February 22, 2011

Re: Comments on the Dominguez Channel and Greater Los Angeles and Long Beach Harbor Waters Toxic Pollutants Total Maximum Daily Loads, Draft

On behalf of the City of Signal Hill, Flow Science is pleased to provide comments on the “Dominguez Channel and Greater Los Angeles and Long Beach Harbor Waters Toxic Pollutants Total Maximum Daily Loads, Draft” (Draft TMDLs). Throughout this letter, the term “Draft TMDLs” is used to refer to Attachment A to Resolution No. R11-XXX, while the term “Draft Staff Report” is used to refer to the Staff Report accompanying the Draft TMDLs.

Figure 6-12. Measured Human-specific *Bacteroidales* Concentrations along the LA River

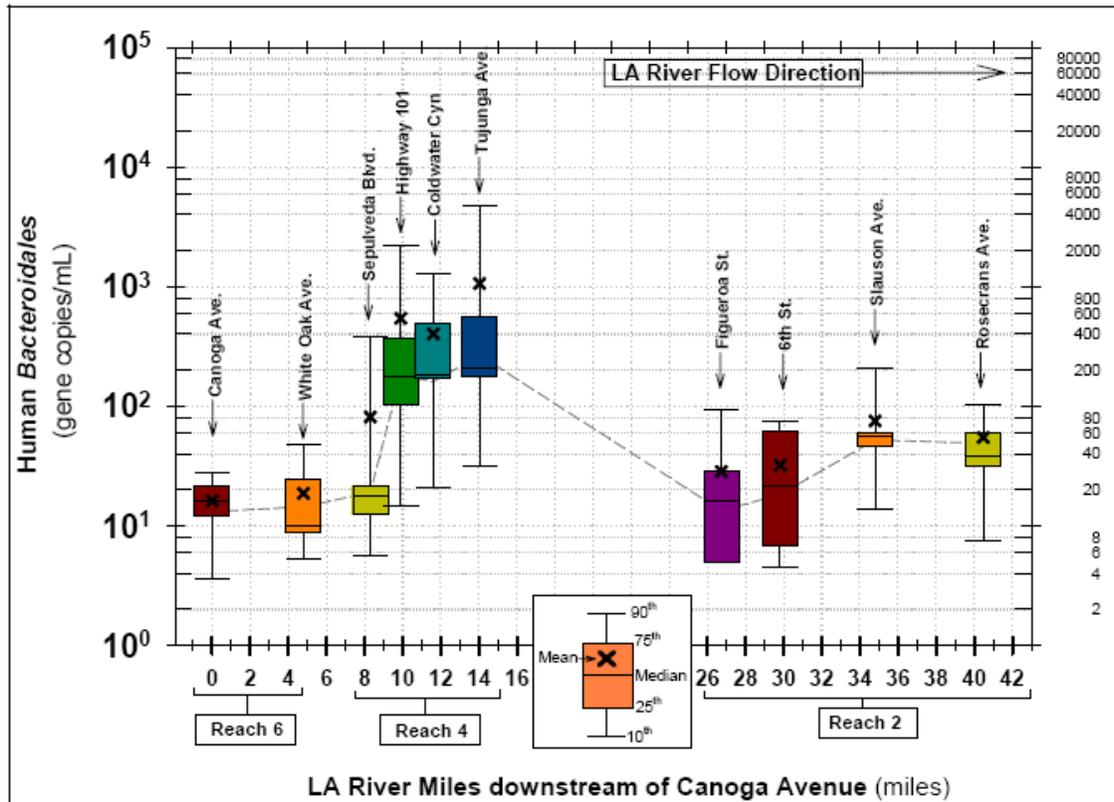
Figure 6-12 presents concentrations of human bacteroidales, measured in the same samples from which the *E. coli* measurements (shown in Figure 6-3) were obtained. Note the concentrations of human bacteroidales increase only slightly in Reach 2 of the river between 6th Street and Slauson Ave. The increase in *E. coli* concentrations in this river segment is far greater (more than one order of magnitude) than the corresponding increase in bacteroidales, indicating that the *E. coli* in this segment is from non-human

sources. These data indicate that non-human sources (which may include wildlife and birds, or regrowth in sediments) are likely responsible for the exceedances of water quality criteria in this river segment.

Figure 2. Figure from initial TMDL document (SARWQCB, 2006).

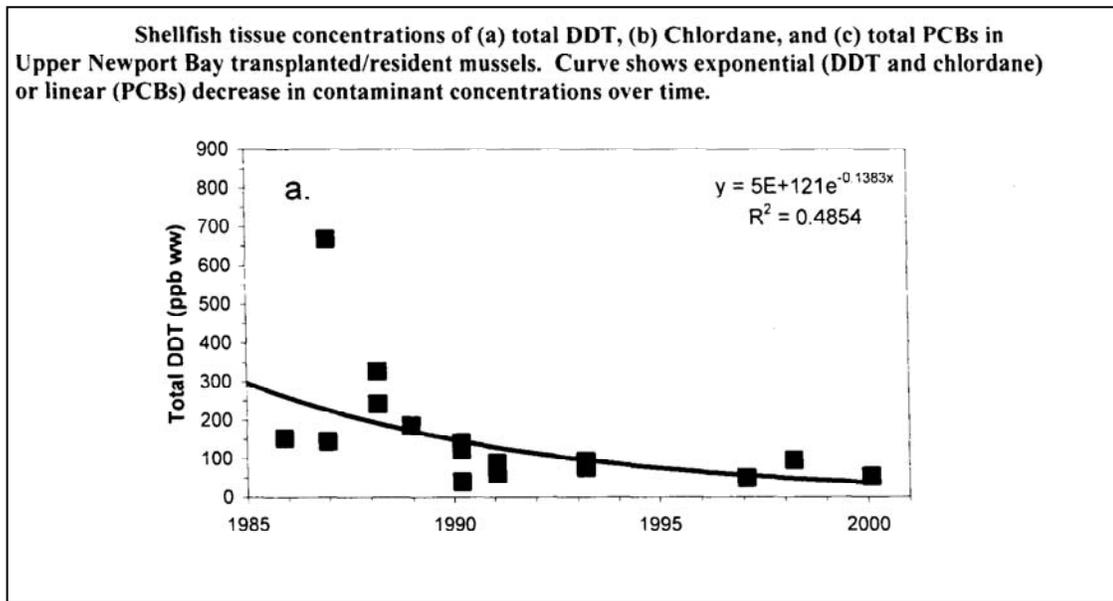
The Panel finds that the declining trend of organochlorine concentrations in red shiner tissue is statistically robust for the period 1980 to 1996, although the strength of the regression relationship declines when the analysis is performed with all data, including outliers. However, data since 1996 fluctuate with no apparent trend, and the regression relationship for the later period (1993–2002) in the split is substantially weaker than that for the earlier time period, although short-term (<10 years) trends in organochlorines with long half lives may be difficult to identify. Furthermore, the relevance of this specific trend to conditions within the Newport Bay is somewhat uncertain because red shiner is a freshwater species and would not likely occur in estuarine conditions in Newport Bay itself. In general, however, declining trends in the red shiner data to about 1990 are supported by data on mussels and less detailed data on tissue levels in striped mullet, which have declined from more than 5000 ppb in the 1970s (Allen et al., 2004) to about 1000 ppb currently (Allen et al., 2008).

Figure 6. DDT concentrations in red shiner collected from San Diego Creek (Source: Stakeholder presentation at April 7, 2009, Panel meeting).

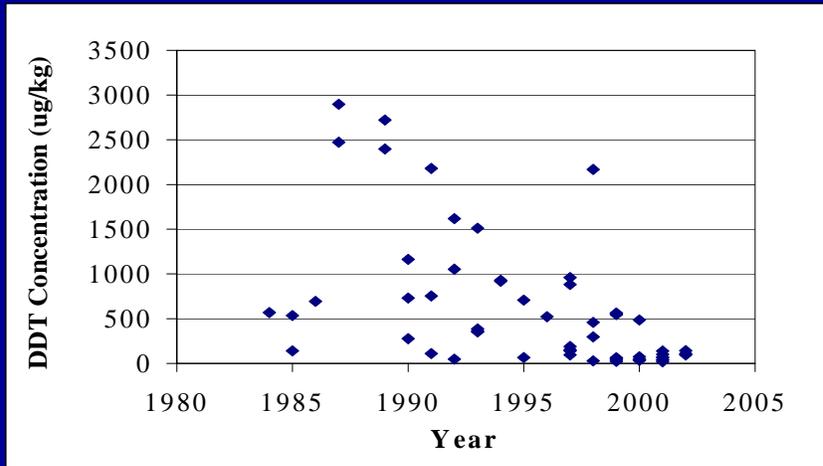
1. Board staff should examine available trend data to determine if they can be interpreted equally well from different perspectives. For example, Figure 6 (taken from the stakeholders' presentation) suggests event-related increases in DDT levels in the late 1980s and again in the late 1990s. These could be associated with periodic increased loads from agricultural lands associated with stormwater or other disturbances, such as construction and changes in land use. Comparison with rainfall and sediment loading records would be useful in testing these possibilities. Such information would provide important insights that are missed by making simplifying assumptions about decay rates.
